ECN/PCN No.: 3728

For Manufacturer			
Product Description: Ultra-Low Noise XO / VCXO	Abraccon Part Number / Part Series: ABLNO	<input checked="" type="checkbox"/> Documentation only	<input checked="" type="checkbox"/> Series
		<input checked="" type="checkbox"/> ECN	<input type="checkbox"/> Part Number
		<input type="checkbox"/> EOL	
Affected Revision: D	New Revision: E	Application:	<input type="checkbox"/> Safety
			<input checked="" type="checkbox"/> Non-Safety

Reflow profile:

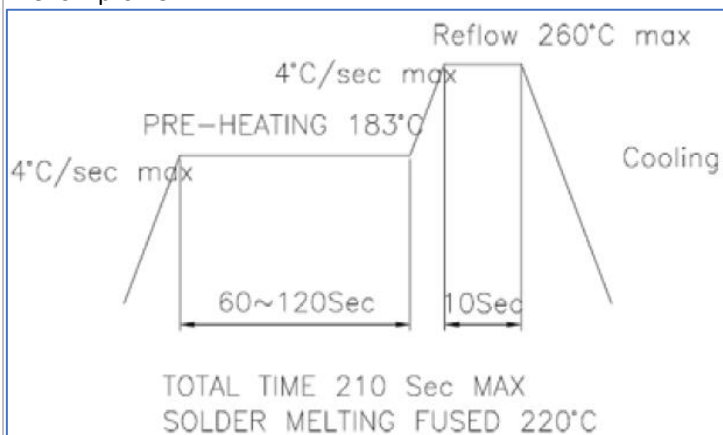
Prior to Change:

Cause/Reason for Change: Updated reflow profile to JEDEC J-STD-020.		
Change Plan		
Effective Date: 09/01/2022	Additional Remarks: n/a	
Change Declaration: The changes attached do not negatively impact electrical or mechanical performance of this series.		
Issued Date: 09/01/2022	Issued By: <i>Brooke Cushman</i> Product Engineer	Issued Department: Engineering
Approval: <i>Thomas Culhane</i> Engineering Director	Approval: <i>Reuben Quintanilla</i> Quality Director	Approval: <i>Ying Huang</i> Purchasing Director
For Abracon EOL only		
Last Time Buy (if applicable): n/a	Alternate Part Number / Part Series: n/a	
Additional Approval: n/a	Additional Approval: n/a	Additional Approval: n/a
Customer Approval (If Applicable)		
Qualification Status: <div style="text-align: center;"><input type="checkbox"/> Approved <input type="checkbox"/> Not accepted</div> <i>Note: It is considered approved if there is no feedback from the customer 1 month after ECN/PCN is released.</i>

After Change:

Reflow profile:
